REGIONAL REVIEW FINDING

ARC REVIEW CODE: R1610251

Name of Proposal: Vinings Atlanta (DRI #2620)

Conceptual Site Plan

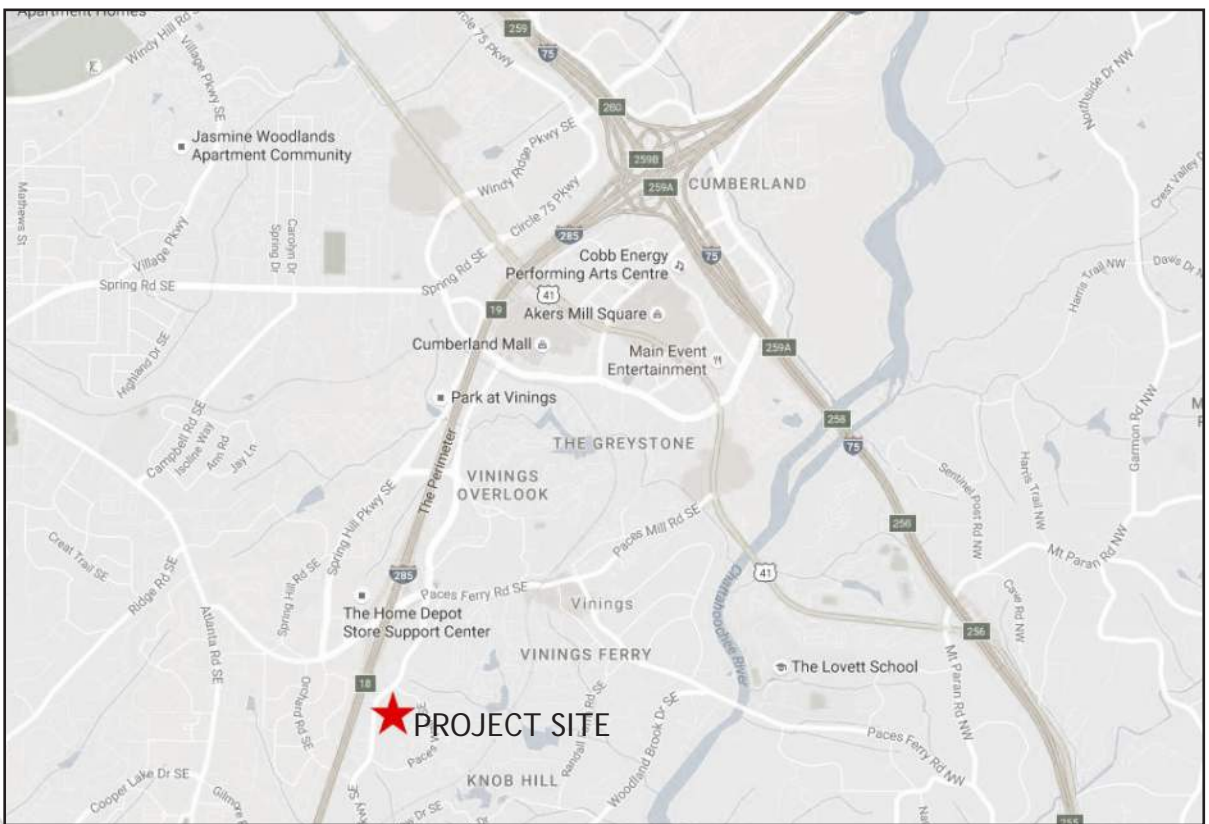
The project site abuts existing single and multifamily residential neighborhoods on the south and east sides. The proposed uses could serve the existing neighborhoods surrounding the project site. The conceptual plan does not depict proposed accommodations for inter-parcel connectivity for vehicles. This may be because of the layout of existing neighboring developments as well as the topographical variations in slope between adjoining parcels.

The site plan depicts proposed sidewalks throughout the development, providing for pedestrian intra-parcel accessibility throughout the site. The site plan and traffic analysis does not note separate facilities for vehicles and bicycles on site, however, proper accommodations may be proposed to allow for safe maneuvering of bicycle traffic commingled with vehicle traffic. The site is adjacent to existing

high density residential on the south side and on the north and east sides along Paces Walk. Paces Walk has no sidewalks along the roadway way connecting pedestrians to the site. In addition, no interparcel connectivity is proposed to the adjacent site.

Pedestrian facilities are provided along Cumberland Parkway adjacent to the project site which provide for pedestrian connectivity to adjoining parcels. The conceptual plan does not depict proposed accommodations for inter-parcel connectivity for pedestrians or bicycles. This may be because of the layout of existing neighboring developments as well as the topographical variations in slope between adjoining parcels. Although sidewalks may be provided along Paces Walk to accommodate pedestrians likely frequently the site, no facilities are presented on the site plan.

The proposed development depicts both residential and commercial uses. Parcels A, B and C propose some measure of commercial, retail or office uses, with Parcel A housing a grocery store underneath apartments. Significant freight traffic may be generated with mostly two to three axle freight carriers delivering on site to small retail stores and office uses. The grocery store is more likely to generate semi truck trailer traffic for deliveries. A loading area appears to be designated for deliveries to the grocery store. The plan does not depict separate travel lanes internal to the site or designate access points in an effort to separate bicycle and pedestrians from truck traffic to and from the site. Paces Walk is a local road which generally does not permit semi truck traffic, therefore truck traffic at this access point may be limited.

It is ARC policy to encourage inter parcel connectivity between developments whenever possible. If topographical conditions permit, sidewalks along Paces Walk connecting to the neighboring residential development should be considered. Designated entrance and exit points for freight carriers, as well as designated delivery hours, should be considered to minimize intermingling of truck and bicycle/pedestrian traffic, increasing safety for all modes.

Paces Walk is a local two lane road looping around to provide two access points to Cumberland Parkway. Paces Walk has no turn lanes. The access point to the project site is close to the access site of

the adjacent residential development. To increase safety and mobility of access to the site, limited use of the Paces Walk access point should be considered.
